OPTIONAL SERVICE BULLETIN NO. DAC1-24-09 REV. 1

SUPERSEDES DAC1-24-09 REV. 0

Type: DA 20-C1

This service bulletin addresses replacement of the firewall battery (either Yuasa Y50-N18L-A-CX or Yuasa YTX24HL-BS or B&C BC100-1MJ) with the Odyssey ODS-AGM28LMJ battery.

Figure 1 - Overview

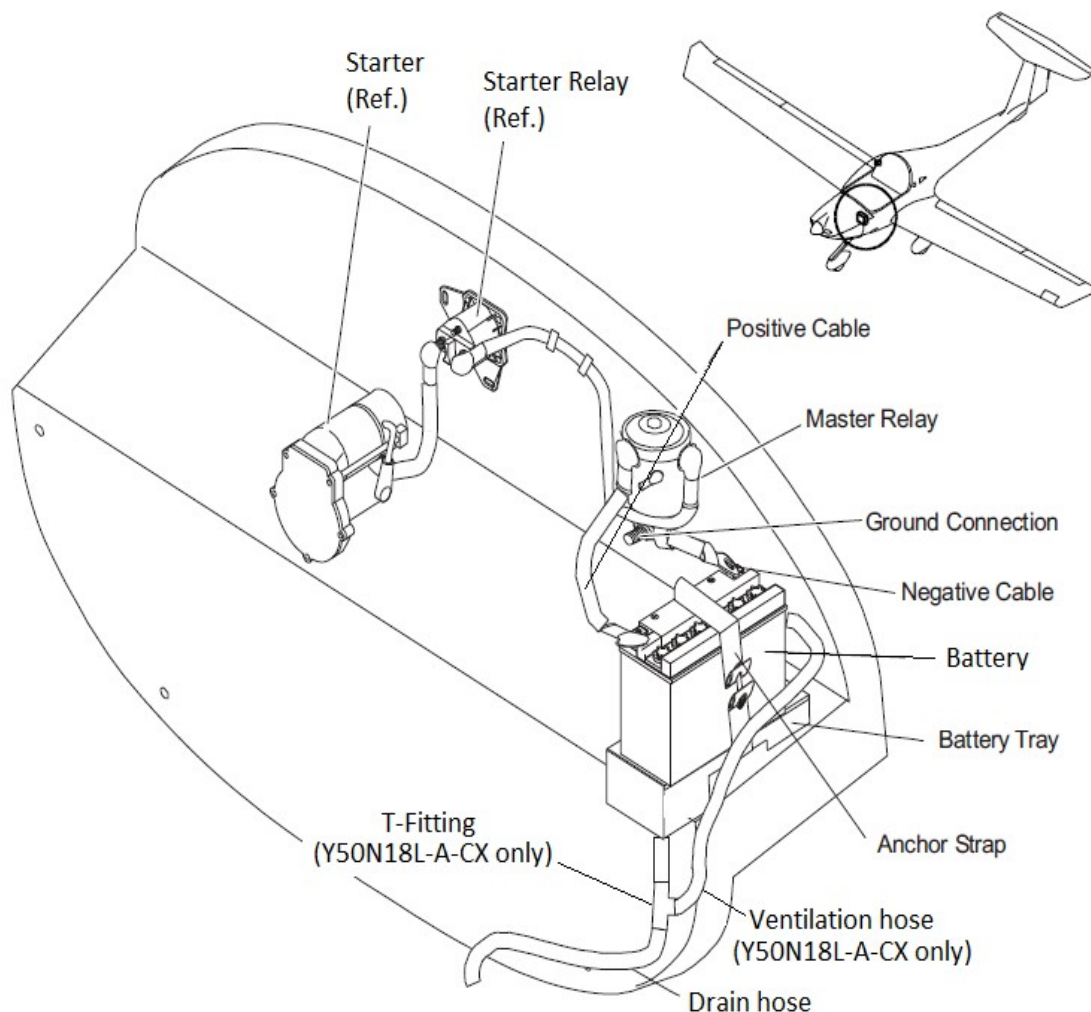
2. Remove and discard the ventilation and drain hose, with T-fitting. Refer to Figure 1.

Figure 2. Firewall, Looking Aft

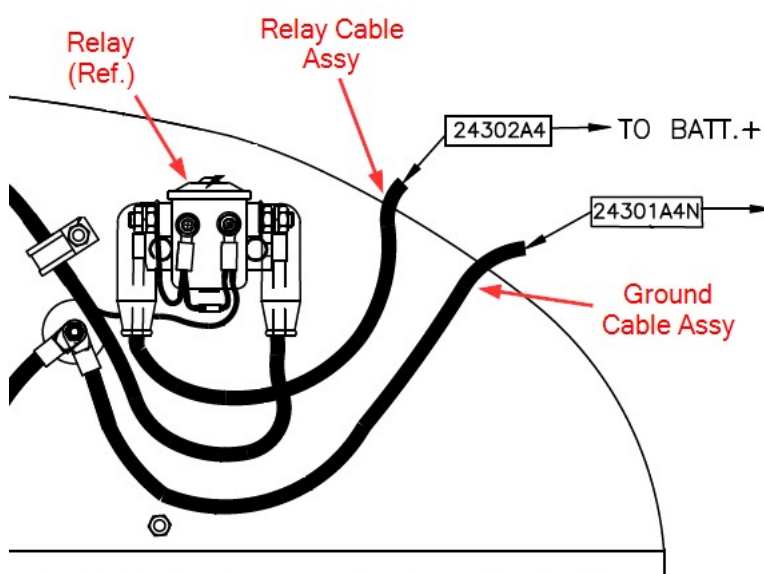
5. Place the Odyssey battery (item 1) on the firewall battery tray. The terminals point outwards of aircraft. Refer to Figure 3.
6. Install the bracket strap (item 4) and battery strap (item 3), secure them using the new hardware (items 12 through 16). Refer to Figure 3.
7. Replace the existing battery relay cable (24302A4) and battery ground cable (24301A4N) with the new ones (items 5 and 6). Refer to Figure 2.

7. Replace the existing battery relay cable (24302A4) and battery ground cable (24301A4N) with the new ones (items 5 and 6). Refer to Figure 2.
8. Connect the relay cable and ground cable to the battery in accordance with AMM Chapter 24-31. Use hardware that comes with the battery.

Figure 3 - Odyssey battery installation

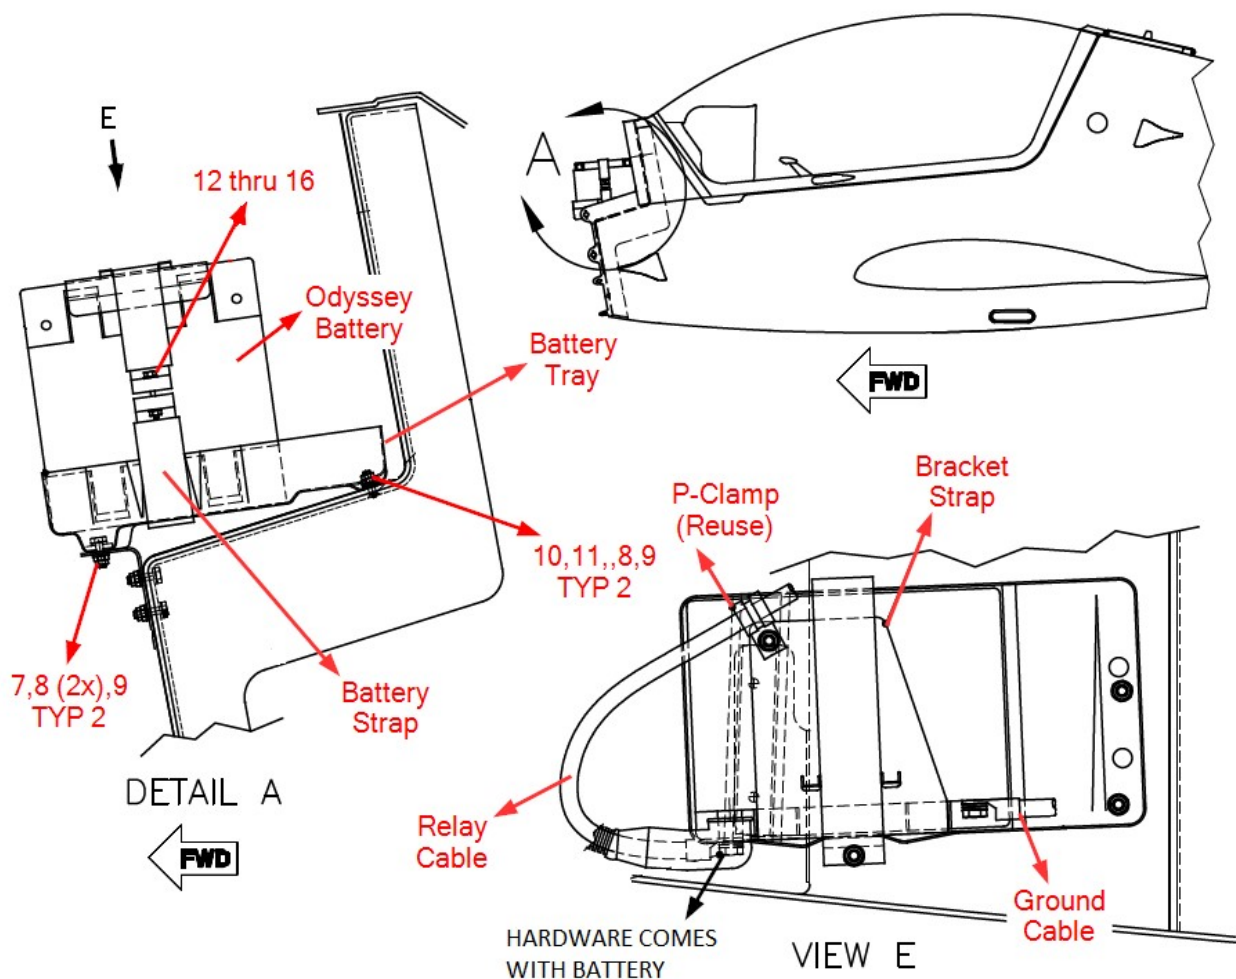
2. Remove and discard the drain hose.
3. Remove the existing firewall battery tray.
4. Install new battery tray (item 2) as follows:
 - A. Position the battery tray by placing the recessed dimples located underneath the aft of the tray over the existing rivets on the firewall. Refer to Figure 3.

- B. Before drilling the holes, push the tray as far aft as possible over the rivets and rotate the forward end of the tray inboard until it is 2 mm away from the oil cooler.

- C. Secure tray and drill using existing holes in firewall and forward mounting bracket.
 - D. Attach the tray using the new hardware (items 7 through 11). Refer to Figure 3.

5. Place the Odyssey battery (item 1) on the firewall battery tray. The terminals point outwards of aircraft. Refer to Figure 3.
6. Install the bracket strap (item 4) and battery strap (item 3), secure them using the new hardware (items 12 through 16). Refer to Figure 3.

9. Secure the newly installed relay cable to the battery with the retained P-Clamp and its attaching hardware from step 1. Refer to Figure 3.
10. Clean the working areas, and check for foreign objects.

1. Remove the BC100-1MJ battery. Refer to AMM Chapter 24-31.
2. Install the Odyssey battery (item 1) using the new hardware (items 12 through 16) on the battery strap. Refer to AMM Chapter 24-31 and Figure 3.
